**DOCUMENT 00 90 00
ADDENDUM**

ADDENDUM NO. [1] Date: February 25, 2021

**RE: ARCADIA SCHOOL DISTRICT
DAYCARE FACILITY REMODEL
350 EAST RIVER ST
ARCADIA, WI 54612
HSR PROJECT NO. 20016**

E100

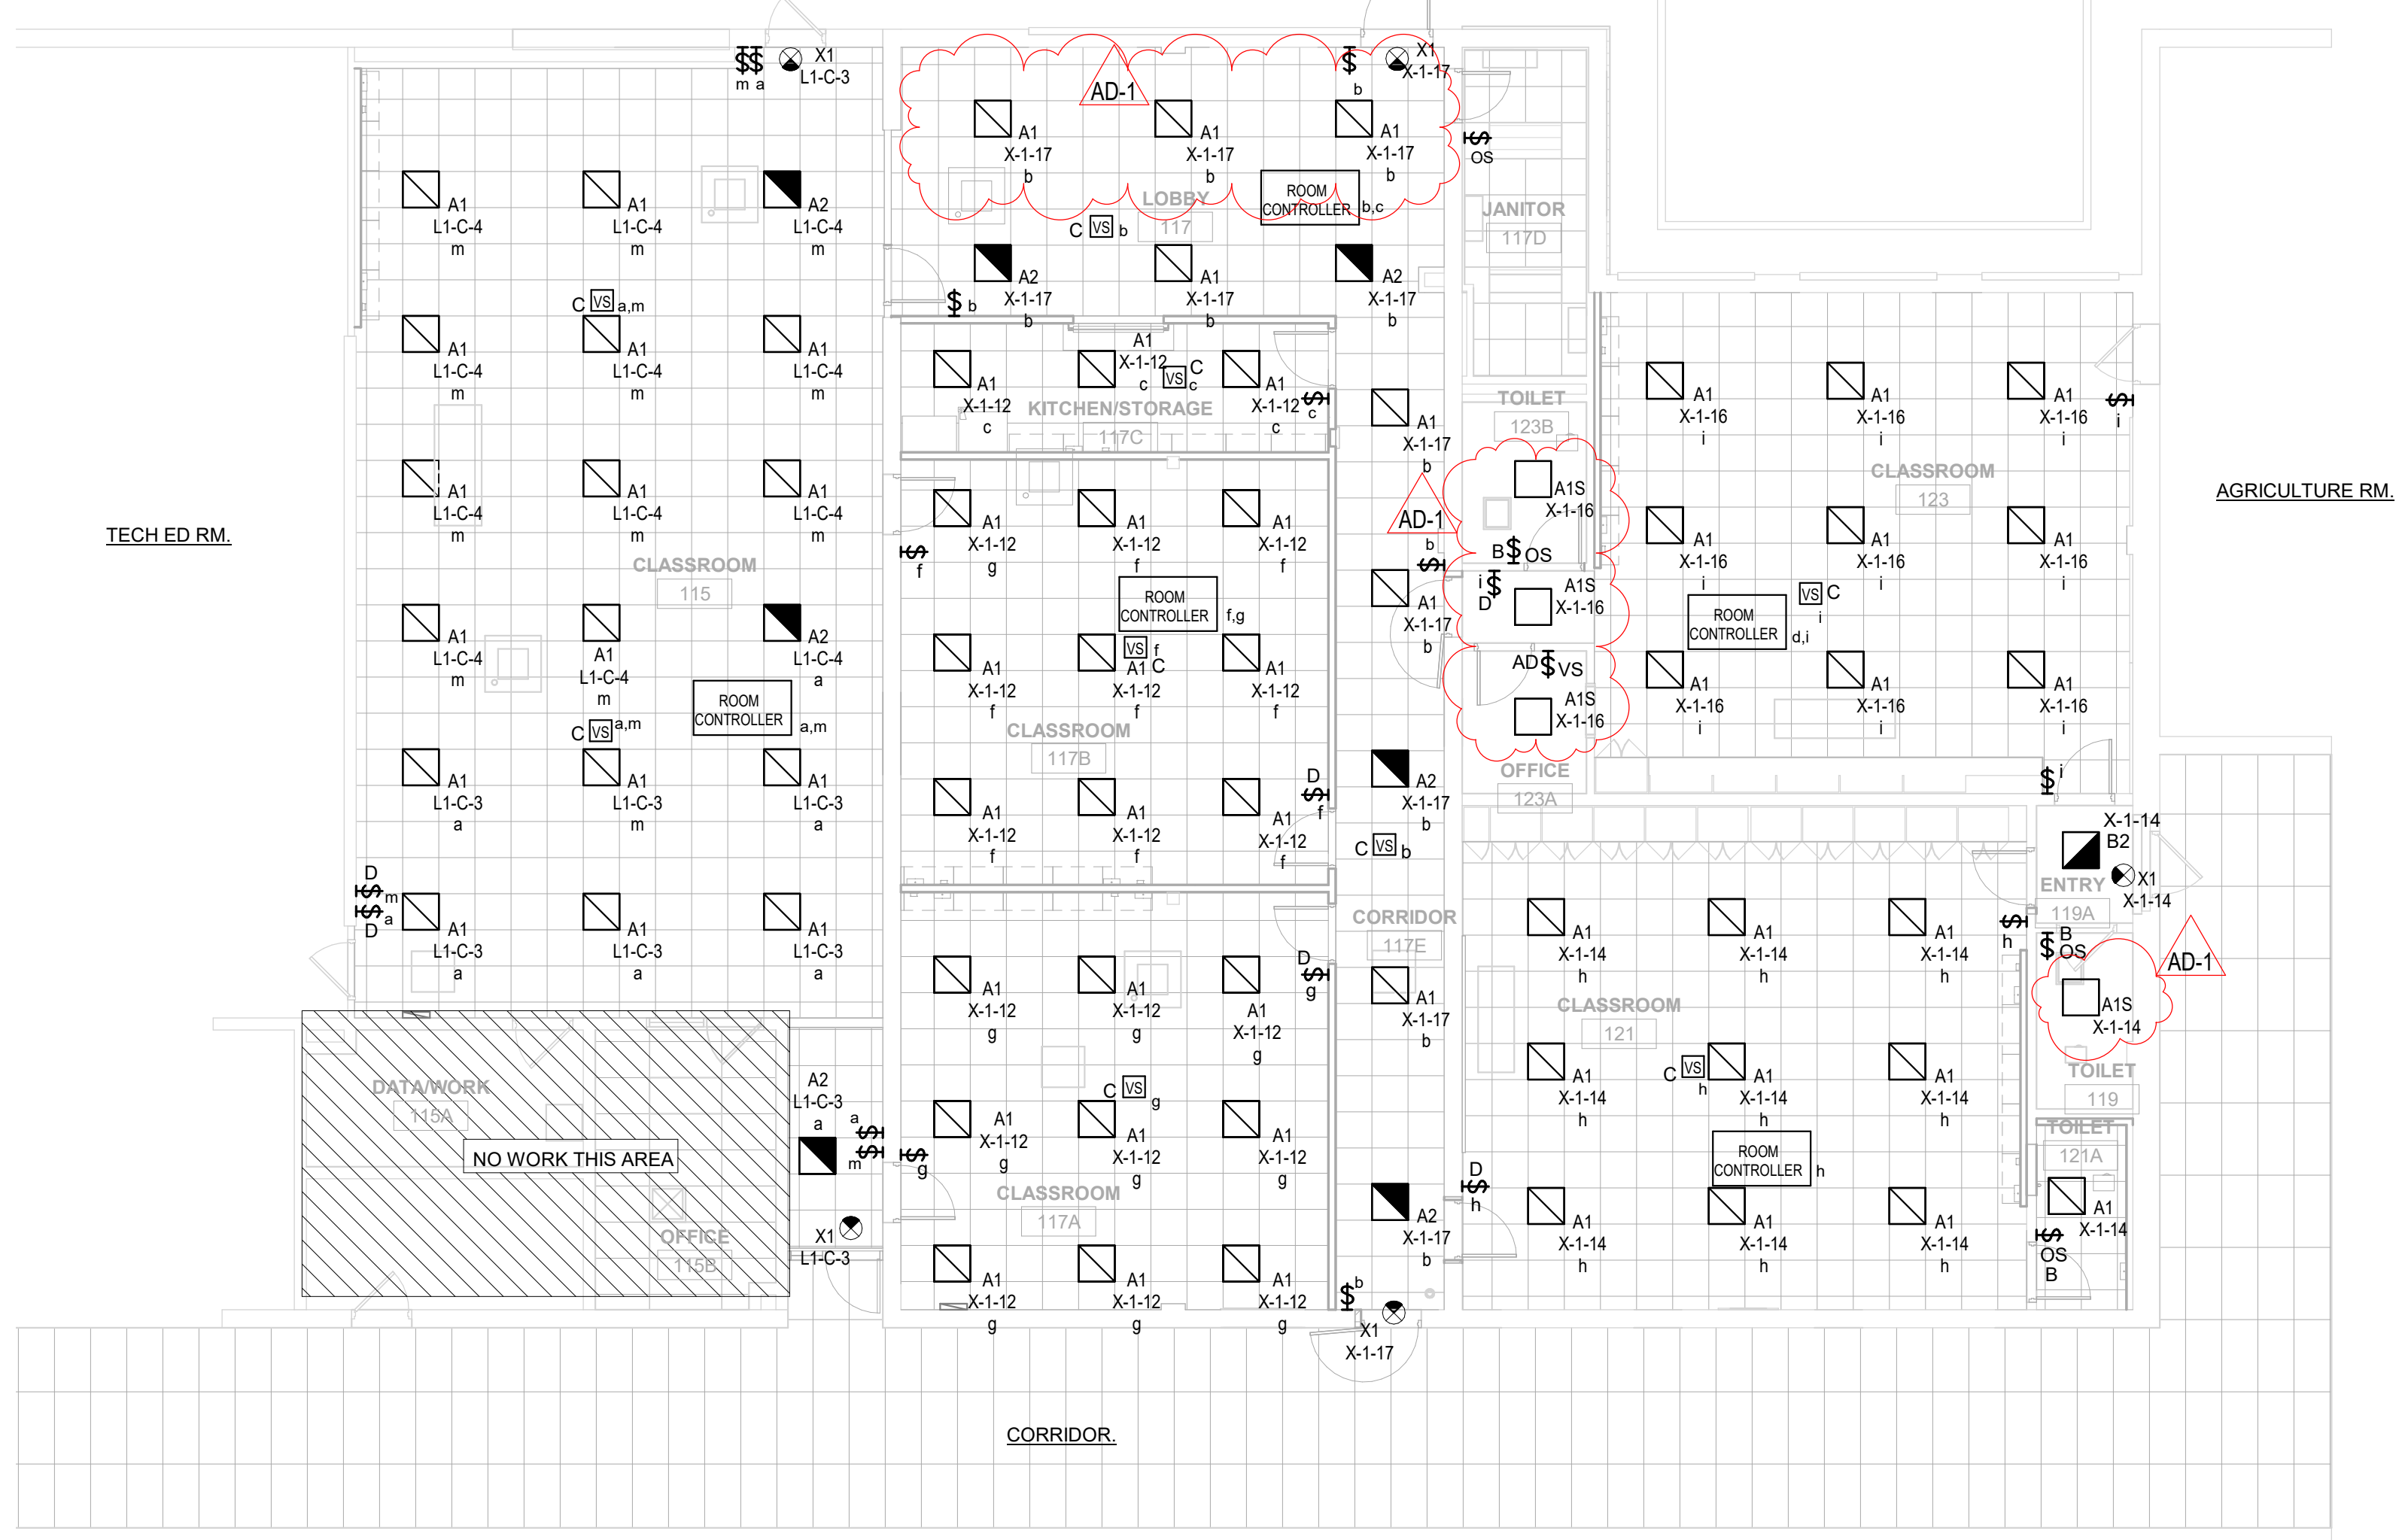
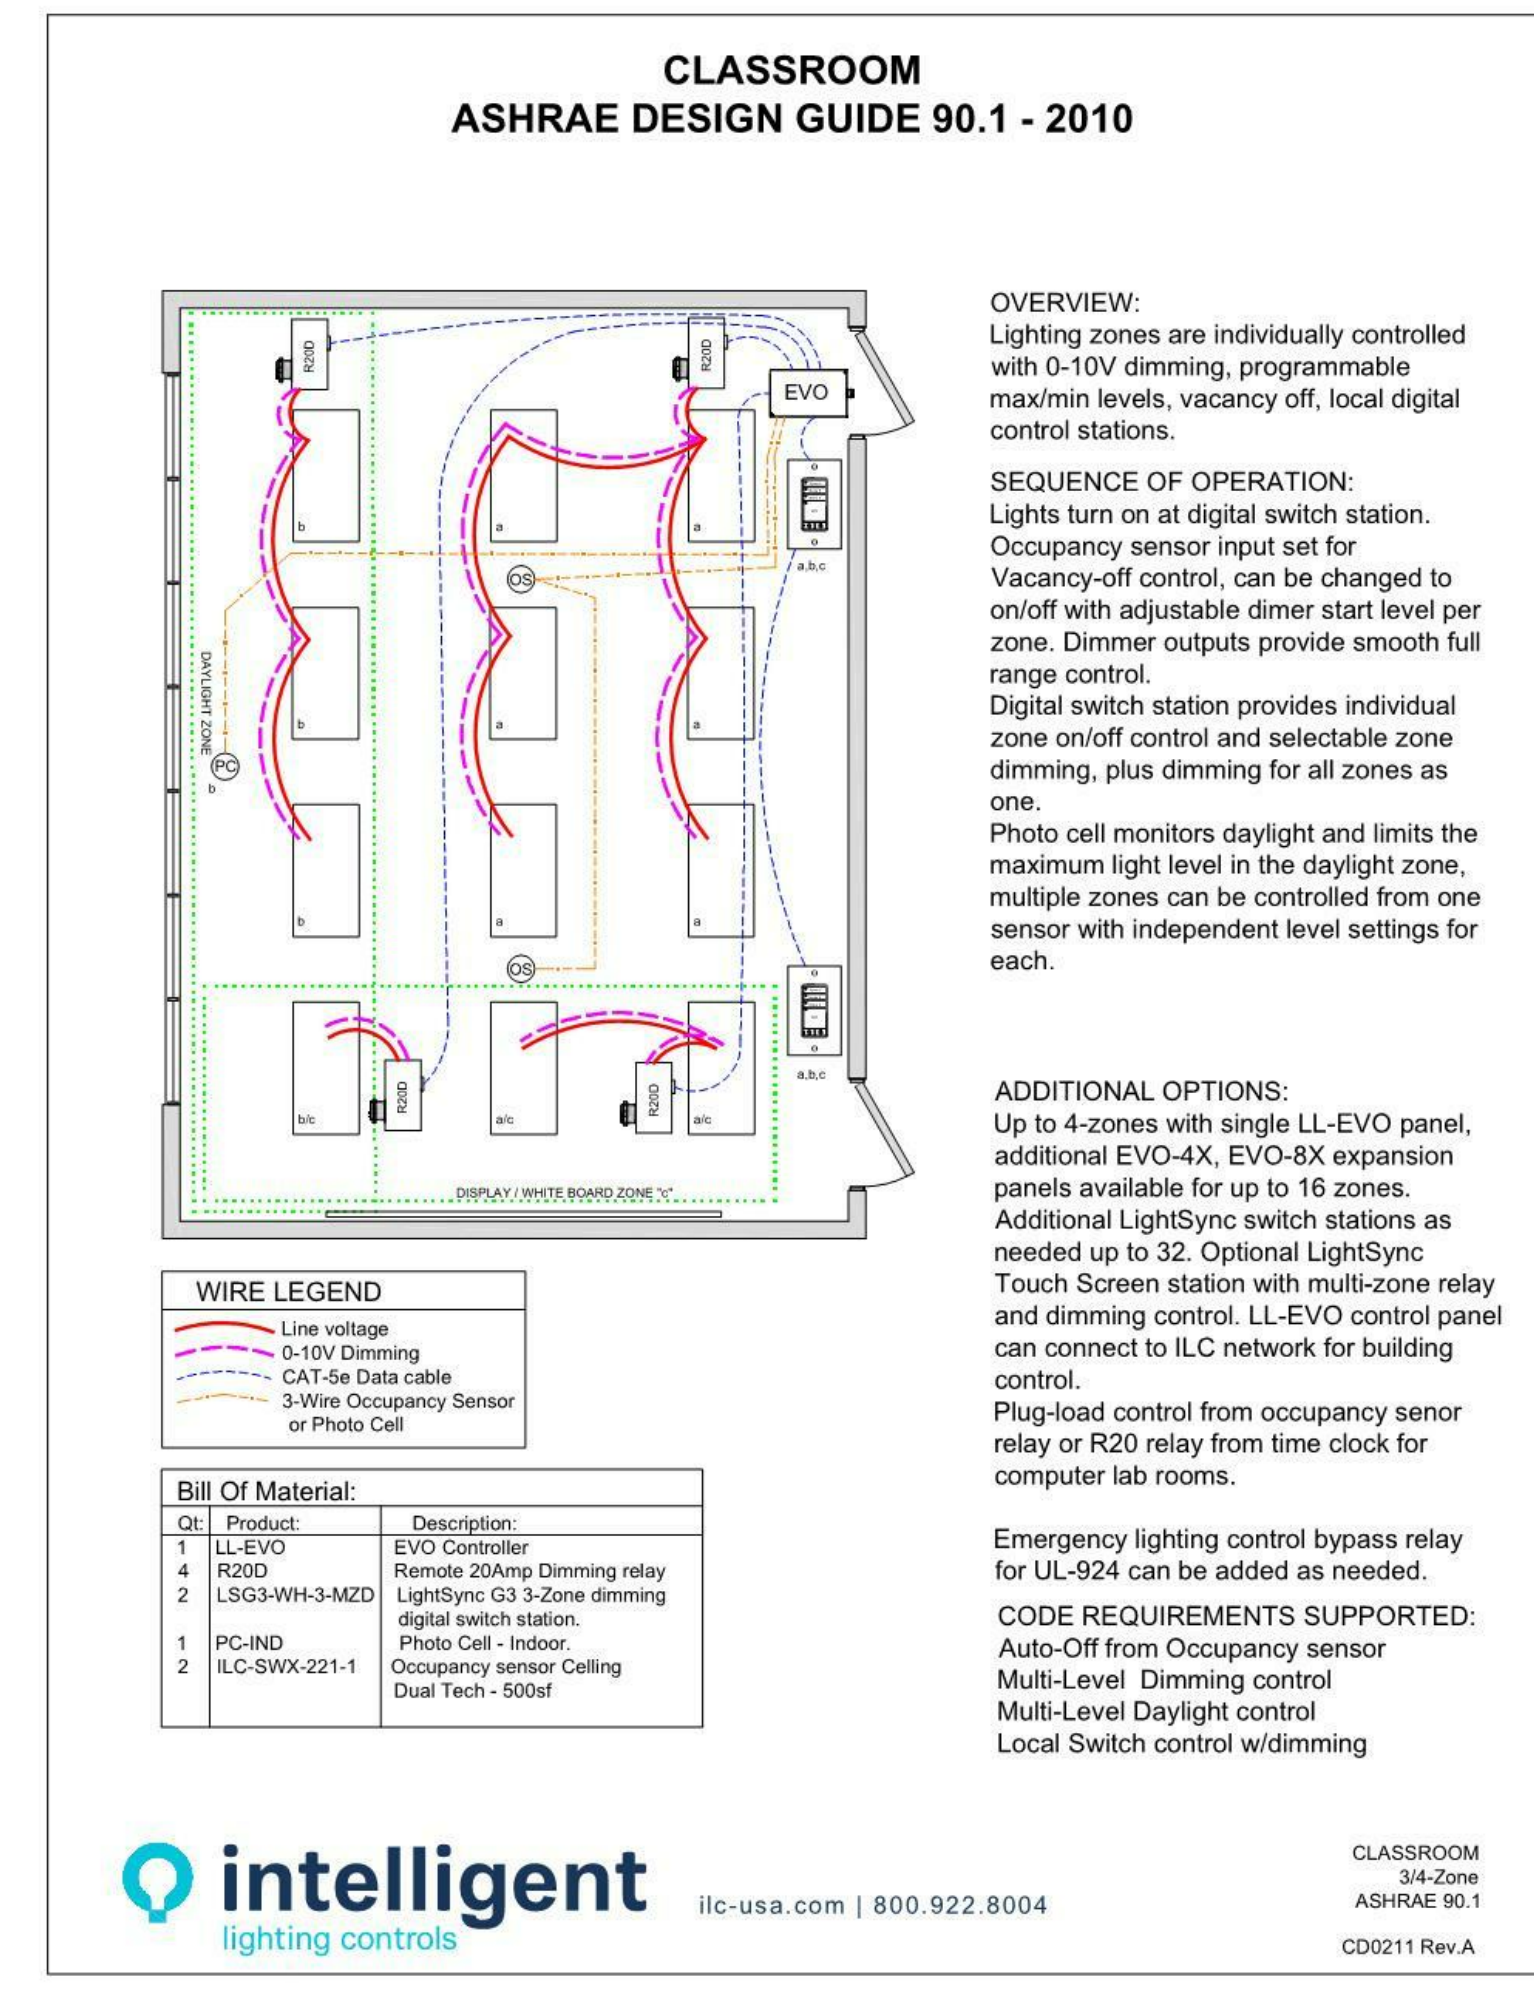
1. Sheet E100 LIGHTING PLANS 30 x 42 attached hereto
 - a. Revisions clouded on Drawing.
 - b. Add Light Fixture Schedule.
 - c. Deleted daylighting area in lobby 117.
 - d. Changed fixture types in Office and Toilets.
